SUBJECT: DEMONSTRATION / DELIVERY HOLD - Safety Recall 14S29 - Supplement #1
Certain 2015 Model Year Lincoln MKC Vehicles
Push-to-Start/Stop Switch Location

New! REASON FOR THIS SUPPLEMENT

- Repair instructions and service labor times are now available for vehicles built before April 22, 2014.
- Parts are now available through normal ordering.

FIGURE 1

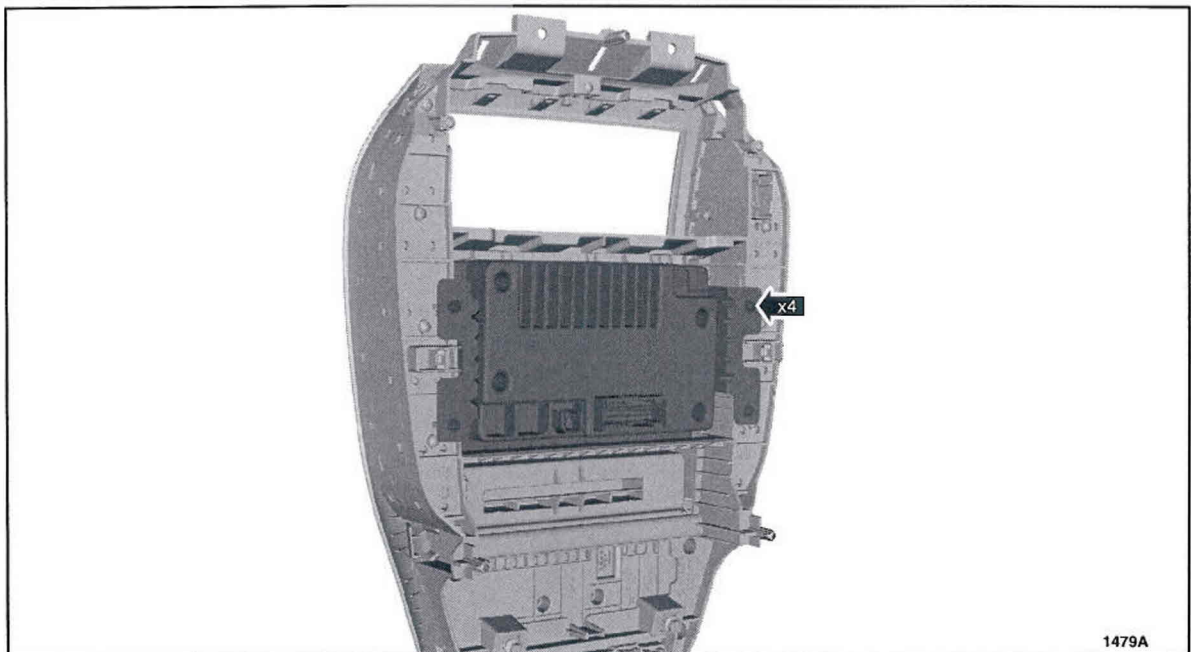
1. Using a diagnostic scan tool, begin the PMI process for the GSM following the on-screen instructions.
2. Remove the Front Controls Interface Module (FCIM). Please follow Workshop Manual (WSM) Section 415-00A.
3. Remove the four retainers and the Front Display Interface Module (FDIM). See Figure 1.

2. Install the GSM trim cover. See Figure 2.
3. Install the FDIM and the four retainers. See Figure 1.
 - Tighten retainers to 2.5 Nm (22 lb-in).
4. Install the FCIM. Please follow WSM Section 415-00A.
5. Using a diagnostic scan tool, complete the PMI process for the GSM following the on-screen instructions.

FIGURE 3

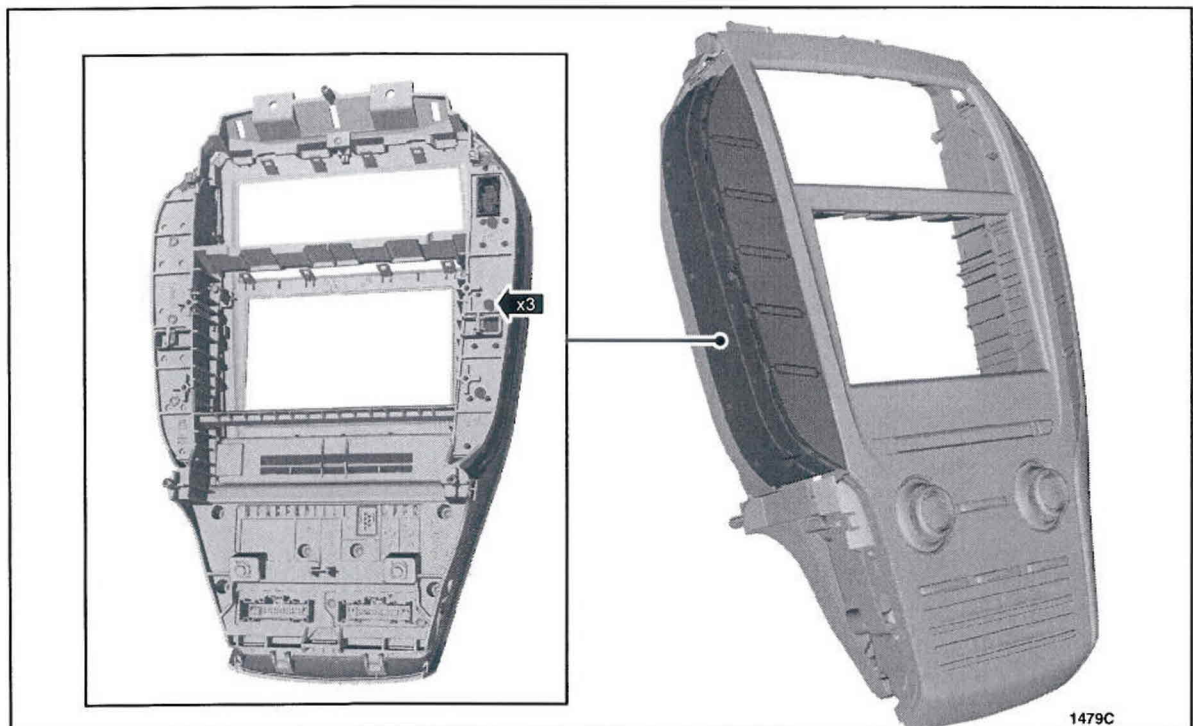
5. Remove the three retainers and the GSM. See Figure 3.

1. Install the GSM and the three retainers. See Figure 3.
